24 April 2024

Hamilton City CouncilBy email: Steve.Denize@hcc.govt.nz

Rotokauri Strategic Infrastructure Notice of Requirement – Part 2 response to Section 92 further information request

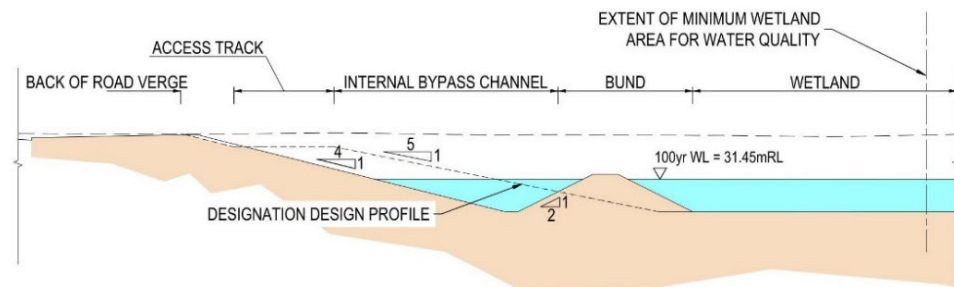
Question 36 Appendix D 5.7.6 High flow bypasses

Please clarify whether these will affect the quantity of land required for the designation.

Response: Provision of high flow bypasses will not affect the land required for the designation. This is based on the following points:

- ii. The RITS design guide, Section 4.2.17.17 notes:

"Peak flow assuming a water level 1/3 of the way between NWL and EDL should be less than 0.05 ms⁻¹ in the WQV event to avoid sediment resuspension and stripping of biofilms".

NWL is the normal water level and EDL is the extended detention level. Using wetland D6C as a test case, the velocity in the water quality event is very low (0.01m/s) due to the width of the wetland relative to the size of the water quality event.

- iii. As reported the average velocity through the wetland G6C in a 100yr event is 0.48m/s as it crosses the forebay weir which is less than the 0.5m/s limit in WRC's guideline noted above for severe events.

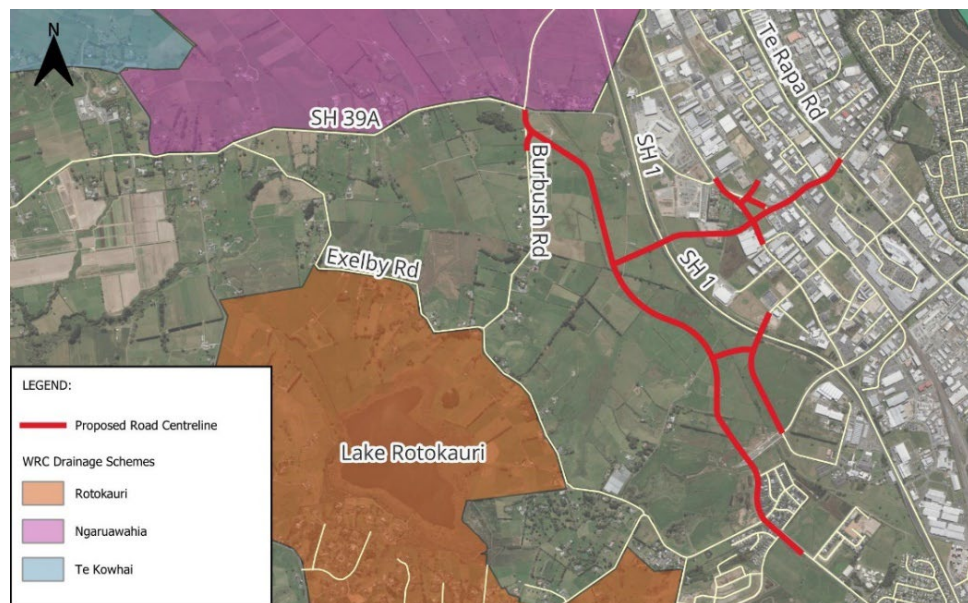
Please confirm which issues will be addressed in future design stages. Are any additional designation conditions required to ensure these are addressed?

Response: The issues that will be addressed are centred on recognition that an effects assessment remains to be completed under a future regional resource consent process. These issues are listed in Section 5.9 of the Design Report.

No additional designation conditions are required to address these.
